Canyon Fuel  
Company, LLC.  
Sufco Mine

RE: Response to March 12, 2008 Letter from Howard Sargent, Forest Supervisor, Manti-La Sal National Forest regarding Sufco Mine's "Summary Report of the 2007 Investigation and Proposed Mitigation Activities, North Water Spring and Joes Mill Pond Areas" November 2007.

## PETERSEN HYDROLOGIC, LLC

Figure 1 Discharge hydrographs for Pines 407 (main fork) and Pines 408 (East Fork) and PHDI for Utah Region 4 (2000-2007).

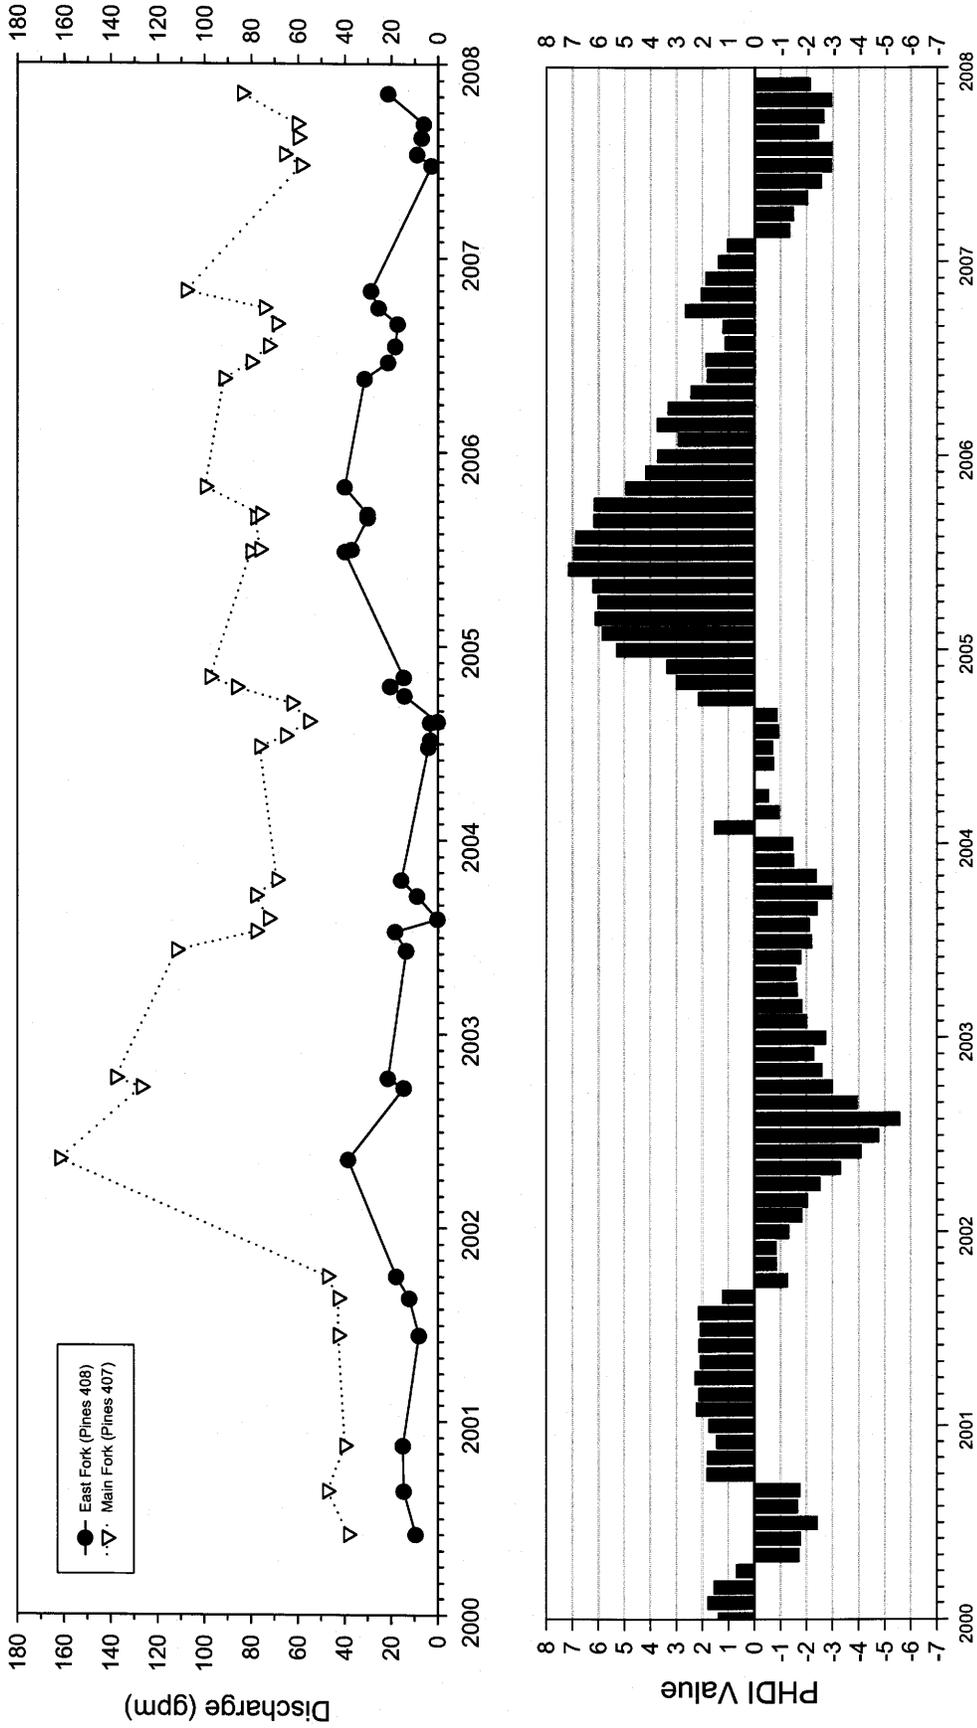
The first comment presented in the letter indicates the Forest believes there is insufficient data presented in the Sufco 2007 proposed mitigation report to conclude "that the total flow in the East Fork of Box Canyon has been maintained". Furthermore, the Forest indicates that a presentation made at a Coal Manager's Meeting by DOGM hydrogeologist Steve Fluke "indicated that the flow has partially recovered" (no date of the meeting was provided). Since the reference to Steve Fluke's presentation has no date, we cannot discern when this comment was made nor address its validity. However, we can address the comment made by the Forest indicating the 2007 summary report lacks sufficient data to conclude the total flow in the East Fork has been maintained. It is important to keep in mind the November 2007 report is one of several that have been written and submitted to the Division and forwarded to the Forest dealing with the issue of the East Fork of Box Canyon flows and mitigation proposals and subsequent actions in the area.

In their 12 March 2008 letter, the Forest Service states that the overall flow in the East Fork of Box Canyon drainage has not recovered since a high in 2002. However, an analysis of monitoring data collected from the area does not support this conclusion. The basis of this statement is provided below.

Mr. Petersen's summary contains data and graphs clearly illustrating that total flows discharging from the East Fork of Box do not appear to have been diminished as a result of mining. Rather, the base flow data clearly indicates changes in discharge are closely related to climatic conditions, exactly what would be expected in an area where aquifers are shallow and respond quickly to changes in precipitation amounts. With the exception of the baseline flow graph, this same information has been provided to the Division, and presumably forwarded to the Forest, in a timely and regular manner.

Discharge in the East Fork of Box Canyon Creek, both prior to and subsequent to its undermining has not been large (Figure 1). Since 2000, discharge monitored at Pines 408 has ranged from a maximum of about 40 gpm during wet years, to less than one gallon per minute during the warm, dry late summer months in dry years. It is noteworthy that the lowest flow rates measured at Pines 408 commonly occur in the late summer months and that there is more discharge measured at Pines 408 in the 4<sup>th</sup> quarter than during the 3<sup>rd</sup> quarter (UDOGM, 2008). This phenomenon is likely the result of evapotranspiration losses in the drainage during warm periods when evaporation rates and plant transpiration rates are appreciable. Diurnal variations in discharge rates have been noted historically in automated recording devices at the flume at Pines 408. These diurnal fluctuations in discharge are attributed to evapotranspiration losses in the drainage during the daytime hours, demonstrating the significance of this effect on stream discharge rates in the East Fork. Because of the small surface-water flows in the drainage (which occur mostly under shallow flow conditions), the loss of even a small amount of water to evapotranspiration would represent a large percentage of the total flow present in the
